Determination 2023/037

The compliance of a waterproof membrane tanking system with Clause E2 of the Building Code

8 Rock Hill Drive, Kennedys Bush, Christchurch

Figure 2. Excerpt from approved plans showing construction detail for the tanking system.

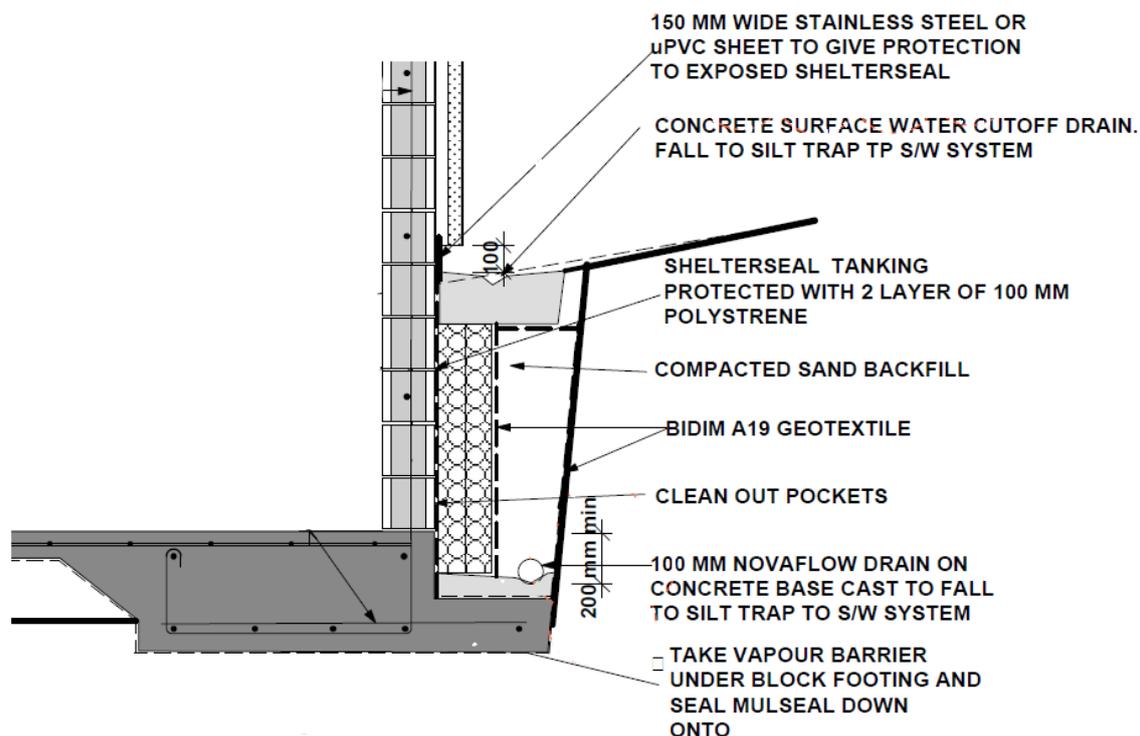
- 5.9. These requirements for the tanking system are reflected on the consented plans (refer to figure 2).
- 5.10. It is not in dispute between the parties that the tanking system, as documented in the appraisal and the consented plans, would comply with the requirements of Clause E2.3.3 if installed in accordance with the requirements set out in this documentation.

- 5.13. However, the findings of the second drainlayer highlighted that the following requirements of the appraisal and consented plans were not met:
- 5.13.1. The two subsoil drains do not discharge correctly to a drainage outlet. This is due to a combination of insufficient gradients, disconnections, and the use of a bubble up sump, which all contributes to allowing water to pool behind the tanking system.

- 5.13.2. The two subsoil drains appear to not be installed at the bottom of the wall. This means a level of standing water is held behind the membrane and backfill level at or above the finished floor level before it can drain away.

- 5.13.3. The second subsoil drain is 65mm in diameter, smaller than the 100mm minimum diameter required as part of the tanking system.
- 5.14. Given these issues identified by the second drainlayer, I agree with the view of the authority that there may now also be issues with the condition of the membrane because of how the subsoil drains have been functioning.

- 5.15. I note that the issues identified are not exhaustive. For instance, the concrete capping as detailed on the approved plans is not shown in as-built photos. This may mean an undue amount of water is able to build up against the retaining wall at ground level, affecting the performance of the membrane or overloading the subsoil drains below.

- 6.1. In accordance with section 188 of the Building Act 2004, I determine that the as-built tanking system does not comply with Building Code Clause E2.3.3.
